240-WLBB-601-001

OUTBOARD PROFILE

TITLE GREAT LAKES ICEBREAKER REPLACEMENT

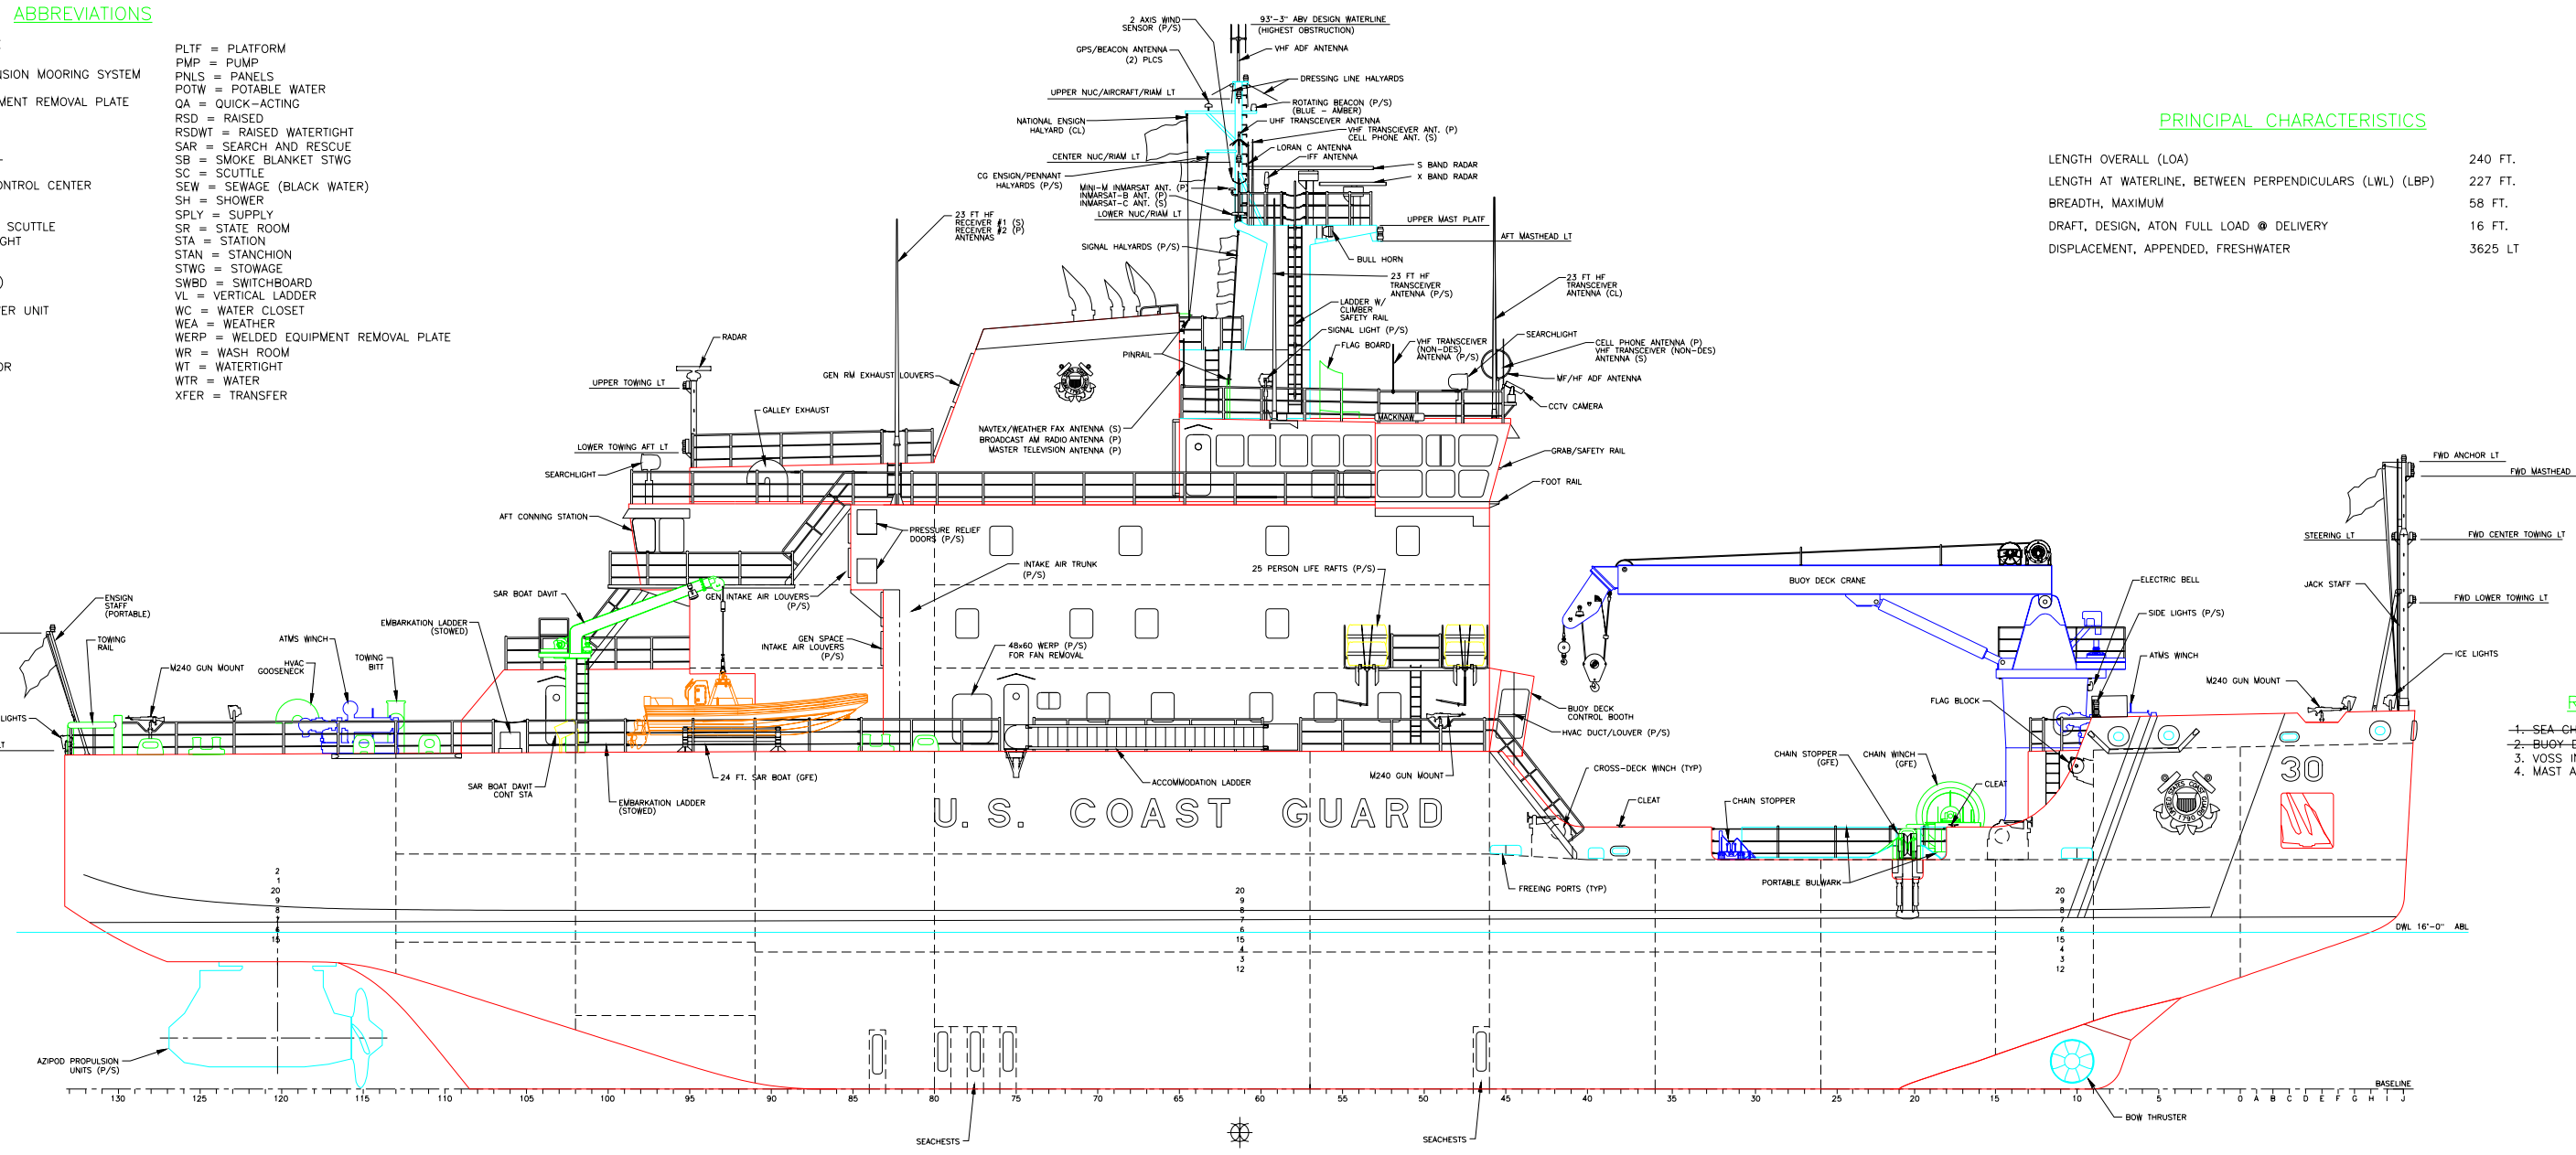
ZONE	REV.	DESCRIPTION	DATE	APPROVED
	-	INITIAL ISSUE. THIS DRAWING WAS DEVELOPED FROM PROPOSAL DRAWING 240 WAGB 601-001 REV A WITH THE FOLLOWING CHANGES:		
VAR		1) ADDED COMPT NUMBERS AND REVISED SOME COMPT NAMES.		
4G		2) ADDED PRINCIPAL CHARACTERISTICS.		
4D		3) CHANGED HULL DESIGNATION NUMBER FROM 12 TO 30.		
28C,40G 52C		4) ALTERED CHAIN LOCKER; DELETED CHAIN BINS AND CREATED P/S CHAIN LOCKERS SIM TO WLB.		
57F		5) CHANGED ENLISTED MESS SEATING FROM STOOLS TO BENCH SEATING.		
16D,23D 28D,64C 71C		6) DELETED ONE ATMS WINCH FWD & ONE AFT, AND ADDED VERTICAL ANCHOR WINDLASSES FWD.		
17D 52F		7) DELETED EXTERIOR LADDER TO FOCSLE ON STBD SIDE AND INCREASED SIZE OF DC NO.2 TO GAIN SPACE ON FOCSLE DK FOR NEW ATMS WINCH ARRGT. ADDED BUILT-IN CO2 LKR FWD.		
23E 71C		8) MOVED CAPSTAN AND TOWING BITT ON AFT DECK FORWARD ABOUT FIVE FEET.	11/20/01	P.HIGHLEN
23D 59B	A	1) MOVED HAWSER REELS & HATCH AFT. ADDED ROPE SCUTTLE ON PORT SIDE. ALL TO IMPROVE LINE HANDLING ON AFT DECK.

4C,16D 59B		2) ADDED 10" BITTS & CHOCKS ON FOCSLE. CORRECTED SIZE CALL-OUT FWD BITTS, WAS 14 IN.		
11D,23E 71C		3) MOVED TOWING BITTS AND CAPSTAN FWD & RELOCATED ATMS WINCHES ON AFT DECK. EXTENDED TOW RAIL TO WRAP AROUND TRANSOM TO SUIT DESIGN CONCERN COMMENTS 9 &10 OF USCG LTR SER 085-GQA-G0013 DTD 10 JAN 02.		
10D,22E 34D,70C		4) DELETED COMPANIONWAY ACCESS ENCLOSURE ON AFT DECK AND ADDED WT HATCH.		
10D,22E 34D,69F 70C,82C		5) ALTERED DECK HOUSE AFT; SHORTENED BY MOVING 01 LVL FAN ROOM TO 02 LVL, AND SHIFTING SERVICE REEL LKRS FWD. HOUSE DID END AT FR.102, NOW FR.98. DELETED CO2 LKR AND DECK GEAR LKR, AND CREATED TWO SERVICE REEL LOCKERS -THIS SEPARATED FUEL HOSE REEL FROM POTW HOSE REEL. CHANGED MEANS TO ACCESS REELS BY ADDING ROLLER CURTAINS IN LEU OF WEAT DOORS. MOVED CO2 BOTTLES TO PASSAGE 01-46-1-L. ALL TO SUIT COMPLIANCE COMMENT 1 OF USCG LTR SER 085-GQA-G0013 DTD 10 JAN 02.		
8E,20D 32E,80F 81C		6) MOVED FAN RM ON 03 LVL TO 04 LVL AFT OF UPTAKE TO IMPROVE DUCT RUNS. REARRANGED IC/GCMPS RM AND PASSAGE ON 03 LEVEL.

18E,30C 54C,54F		7) RELOCATED CARGO HOLD AFT ONE COMPARTMENT TO GET CARGO HATCH OUT OF BUOY SERVICE AREA. RECONFIGURED POTW TANKS AND MOVED GRAY WTR TANKS FWD ONE COMPT.		
5D,17C 21F,65B 67F,69D		8) DELETED SURVIVAL SUIT LKR 02-46-0-A AND ADDED EXTERIOR STOWAGES FWD AT FOCSLE DECK EDGE, AND AFT ON PORT SIDE NEAR BOATS. INCREASED SIZE OF SURGE BERTHING SPACE TO TAKE UP SPACE WHERE SURVIVAL SUIT LKR WAS. NOTED SPACE AVAILABLE FOR ADDITIONAL BERTHING. ALL TO SUIT ENHANCEMENT COMMENT 5 OF USCG LTR SER 085-GQA-G0013 DTD 10 JAN 02.		
5C,18D 54F		9) REPOSITIONED GRIPERS ON BUOY DECK TO IMPROVE FLEET ANGLE FOR TIE-DOWN. ALSO ENLARGED BUOY PORTS TO PROVIDE MIN. 15 FT. CLEAR OPENING BETWEEN STOPPERS.		
32C 55-57F		10) REARRANGED MAIN DECK BETWEEN FRAMES 46-91; MOVED PROPULSION SWBD & TRANSFORMERS TO 1ST PLTF SPACES. CHANGED STBD THRU PASSAGE TO NEARER CENTERLINE. MOVED MED TRTMT RM, LOG OFFICE & DECK WR,WC. MOVED ECC, EL SHOP & MACH SHOP FROM 1ST PLTF. DELETED DC CENTRAL, COMBINED IT WITH ECC AND LOCATED ECC OUTSIDE OF MACHINERY SPACE ENVELOPE TO SUIT DESIGN CONCERN COMMENT 11 OF USCG LTR SER 085-GQA-G0013 DTD 10 JAN 02. RELOCATED AND INCREASED SIZE OF CPO MESS & OFF WARD RM TO SUIT COMPLIANCE COMMENTS 2& 3 OF USCG LTR SER 085-GQA-G0013 DTD 10 JAN 02. ADDED SPACE FOR FUTURE TRASH HOIST ON MESS DK

54C		11) MOVED DC SHOP FROM AFT OF AMR NO. 2 TO FR.26-36 ON 1ST PLATFORM.		
55C		12) DELETED R.O. ROOM, CENTERLINE PASSAGES AND HEATING EQPT RM FR.46-57, AND CREATED MOTOR GEN ROOM IN THIS COMPARTMENT. MG SETS & TRANSFORMERS MOVED FROM AMR NO. 2 FWD INTO THIS NEW SPACE.		
56C		13) CREATED SWBD OPERATOR'S RM IN UPPER LEVEL OF GEN RM WHERE ECC WAS LOCATED. MOVED PROPULSION SWBD, TRANSFORMERS & NEUTRAL POINT RESISTOR UNITS INTO THIS NEW SPACE.		
57C		14) REARRANGED UPPER LEVEL OF AMR NO. 2 ADDING PROP TRANSFORMERS & DRIVE UNITS, AND RENAMED SPACE AS PROPULSION TRANSFORMER RM. MOVED A/C UNITS AFT.		
58C		15) MOVED EL SHOP & MACH SHOP TO MAIN DECK. MOVED EXERCISE RM, SHIP STORE & SEABAG LKR FWD ONE COMPARTMENT. DELETED HYDR PWR UNIT RM NO. 1 & 2 AND CREATED HYDR MCHRY RM NO.2.		
53F,58F		16) ADDED SCBA FILL STATION IN CRANE PEDESTAL AND SCBA STOWAGES AT FR.6&108 ON MAIN DECK.		
43F		17) REDUCED SIZE OF FUEL SERVICE TANKS, INCREASING SIZE OF AMR.

42F		18) ADDED SP & WT IN POTW MCHRY RM FOR R.O. UNIT.		
69C		19) RELOCATED LAUNDRY & TRASH RM TO ALLOW FOR FUTURE TRASH HOIST NEAR CENTERLINE.		
		(REVISION A CONTINUED ON SHEET 2)
